EGLIN AIR FORCE BASE, FLORIDA
JSF ACADEMIC TRAINING CENTER (ATC)
PROJECT NO. FTFA083950
AS-BUILT
MECHANICAL PIPING
FIRST FLOOR PLAN
— AREA A

EGLIN AIR FORCE BASE, FLORIDA
JSF ACADEMIC TRAINING CENTER (ATC)
PROJECT NO. FTFA083950
AS-BUILT
MECHANICAL PIPING
FIRST FLOOR PLAN
AREA B

EGLIN AIR FORCE BASE, FLORIDA
JSF ACADEMIC TRAINING CENTER (ATC)
PROJECT NO. FTFA083950
AS-BUILT
CHILLED WATER SYSTEM
CONTROL SCHEMATIC
SEQUENCE & POINTS LIST

AS-BUILT
PLUMBING
BELOW RAISED FLOOR &
BELOW GRADE PLAN AREA A

M-119

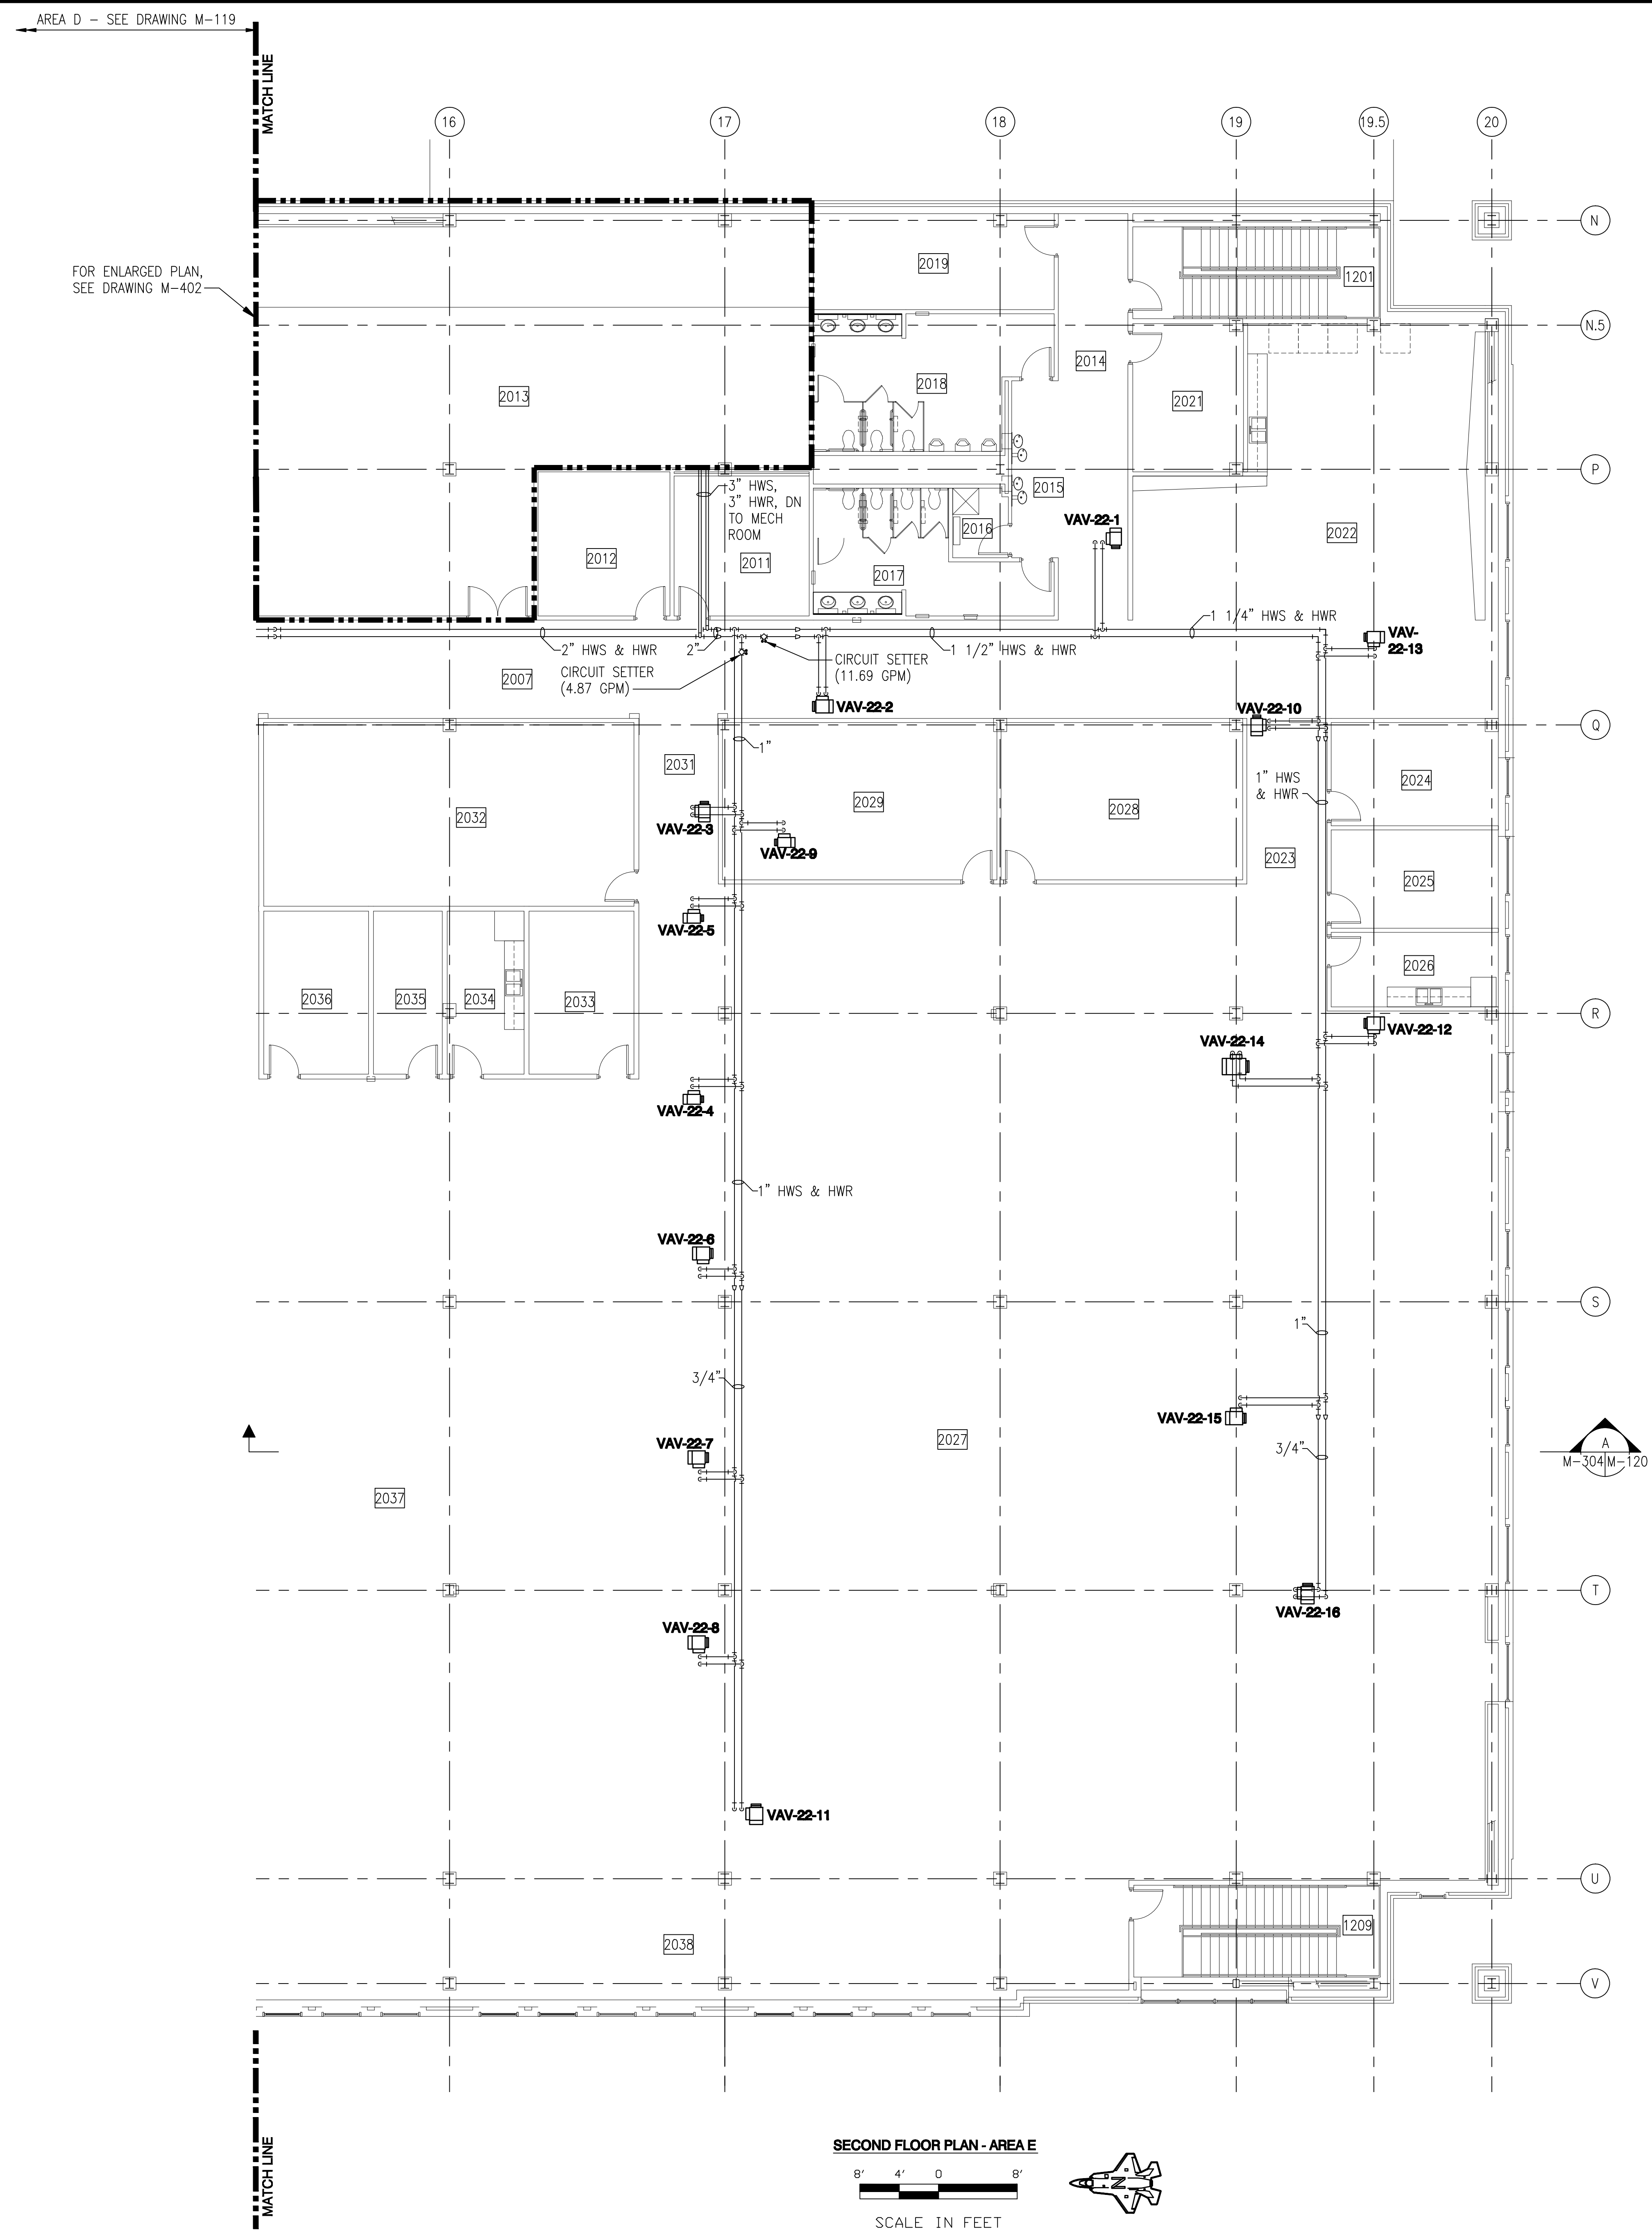
Revisions	Symbol	No.	Description	Date	Approved
3	AS-BUILT	FIELD CHANGE - RELOCATED CHILLED WATER/HOT WATER SUPPLY AND RETURN

M-717

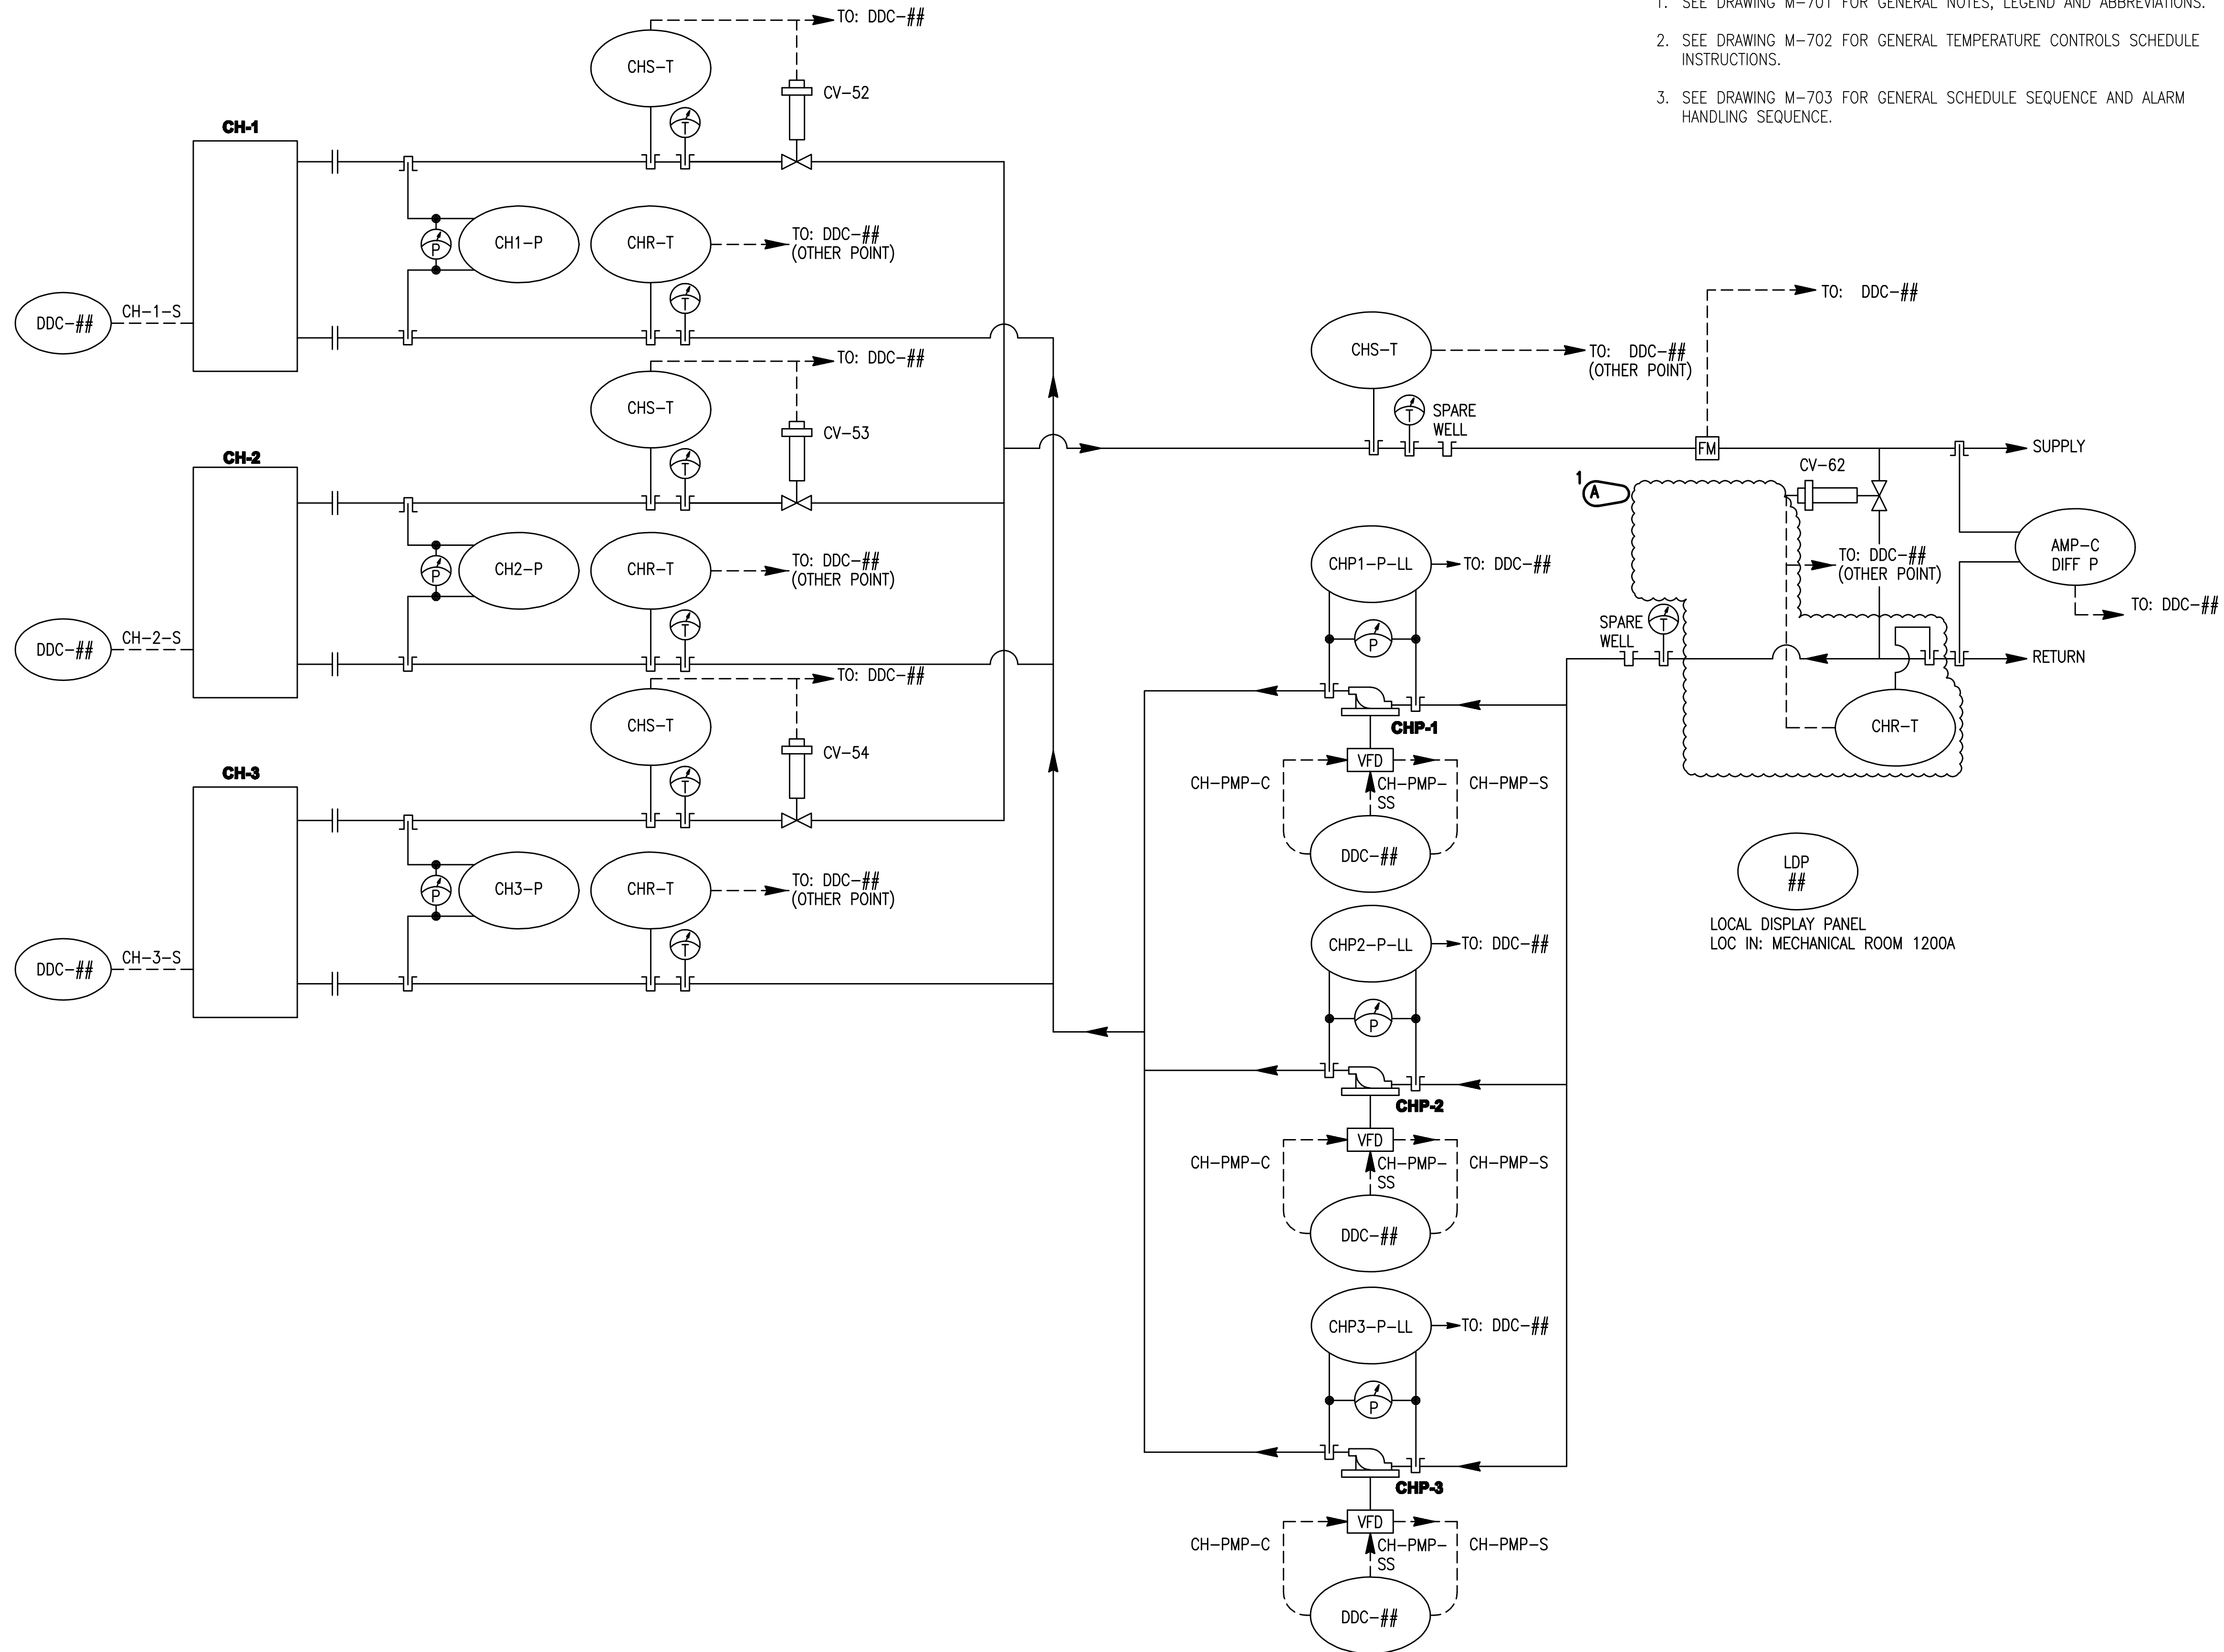
Revisions	Description	Date	SPR	Approved
2	REVISED FOR RFI 238 & 241	5/10/10		
1

Sheet
Reference
Number:
P-101

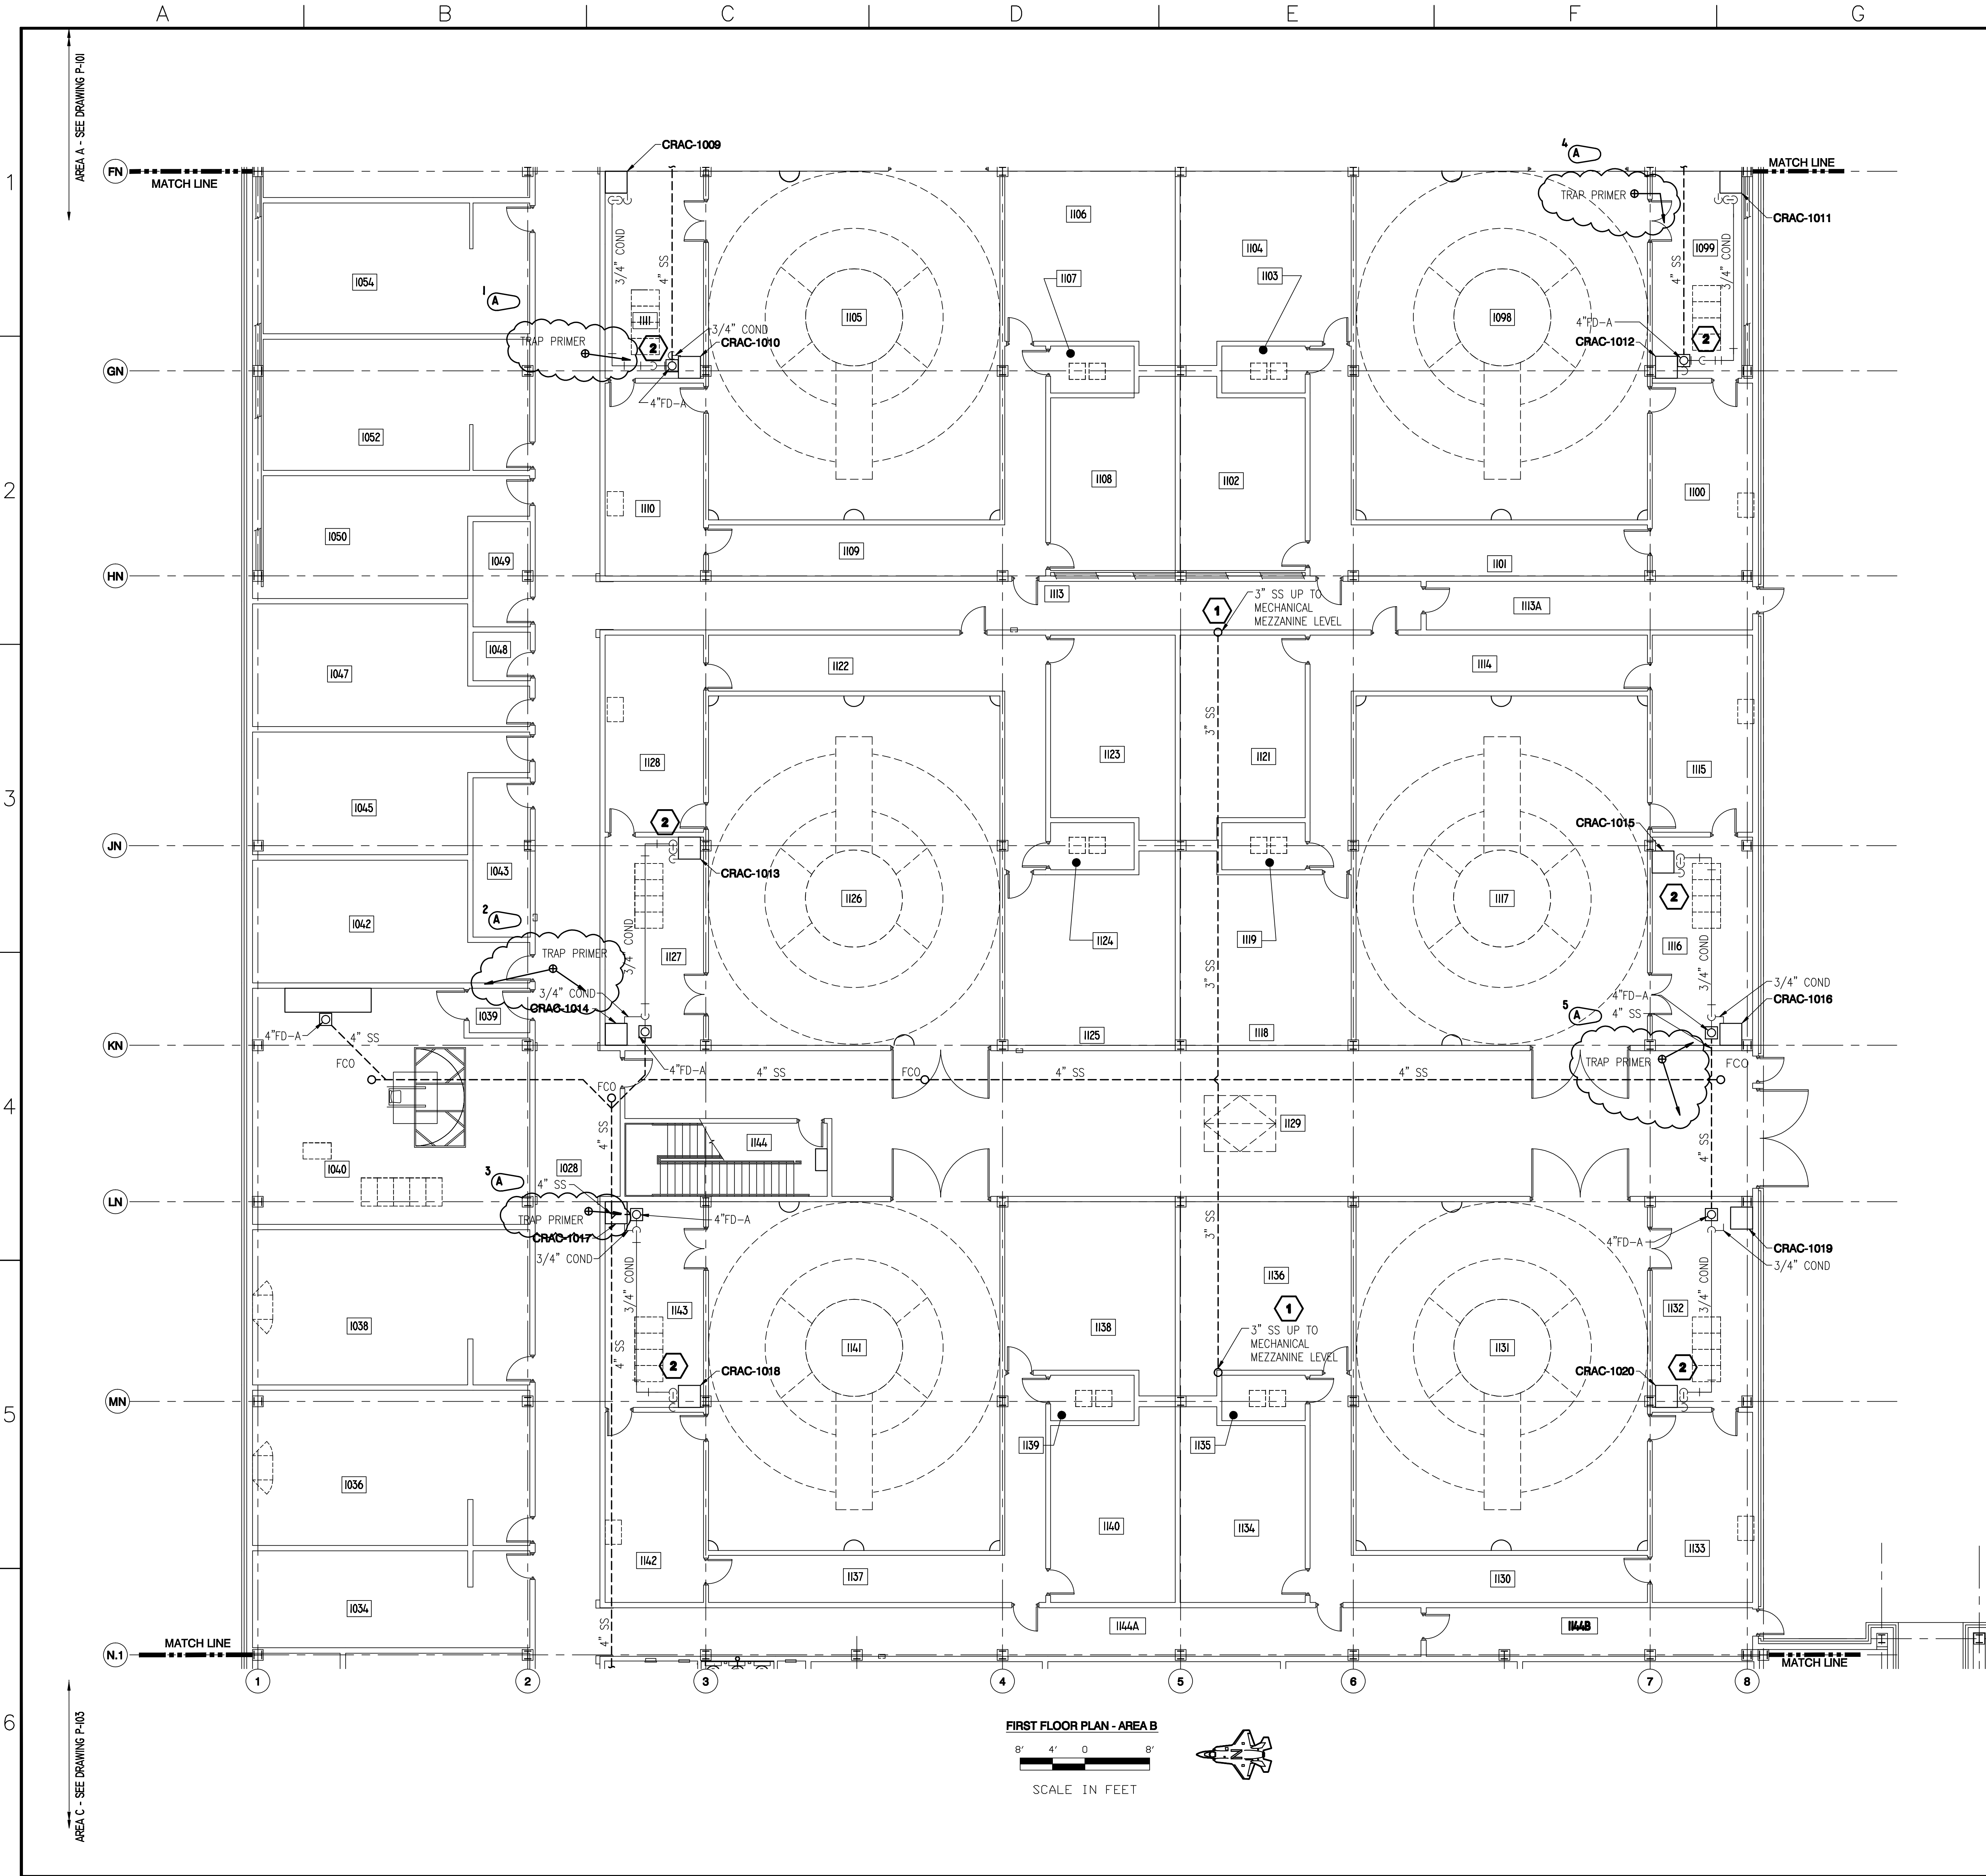
Symbol	No.	Description	Date	Approved
1	AS-BUILT: FIELD LOCATION OF 4" SS LINE		06/14/09	DH
2	AS-BUILT: TRAP PRIMER LOCATIONS		XX/XX/XX	DH
